UNITED STATES
NUCLEAR REGULATORY COMMISSION
WASHINGTON, D.C. 20555-0001

APPLICANT: Westinghouse Electric Corporation
FACILITY: AP600
SUBJECT: SUMMARY OF APRIL 15, 1997, MEETING WITH WESTINGHOUSE TO DISCUSS
ISSUES ASSOCIATED WITH THE AP600 PROBABILISTIC RISK ASSESSMENT
(PRA)

AP600 DESIGN PRA REVIEW

Figure 1 - AP600 SG Tube Rupture Levels of Defense

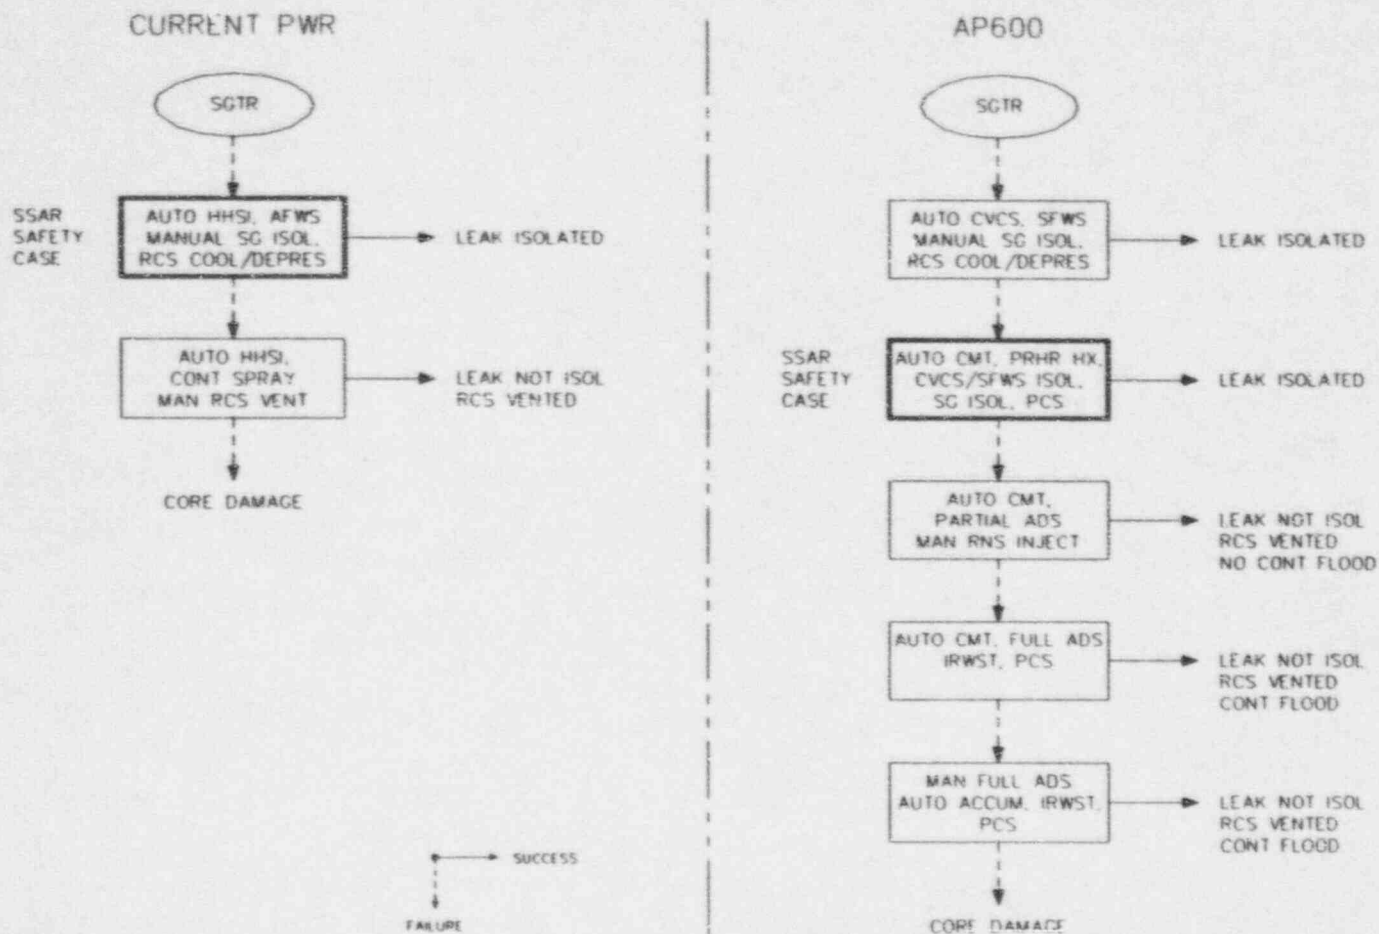
The staff was concerned with the lack of thermal-hydraulic analyses supporting the assumption that the AP600 design can use non-safety related systems only as the first line of defense to mitigate SGTR accidents. Westinghouse believes that the AP600 has unique features that make the AP600 SGTR response different from other pressurized water reactors. Additionally, Westinghouse stated that they were answering similar questions about SGTR events from the Reactor Systems Branch. The staff agreed to have the Reactor Systems Branch involved in the review of the thermal-hydraulic analyses that Westinghouse will be providing in response to concerns regarding the PRA SGTR modeling.

- Lack of T-H analyses supporting the assumption that the AP600 design can use nonsafety-related systems only as the first line of defense to mitigate SGTR accidents
- Lack of T-H analyses supporting success criteria and modeling of sequences involving failure to trip one or more RCPs
- The staff asked W for such analyses over a year ago
 - W responded w/o the analyses
 - staff followed up
 - Waiting for W's response
 - impact on baseline and focused PRAs

- Received more RAls in March 1997 requiring additional T/H analyses.
Mainly concern the use of CVS and operator actions.

These questions can be answered verbally today.
The written responses will be available soon.
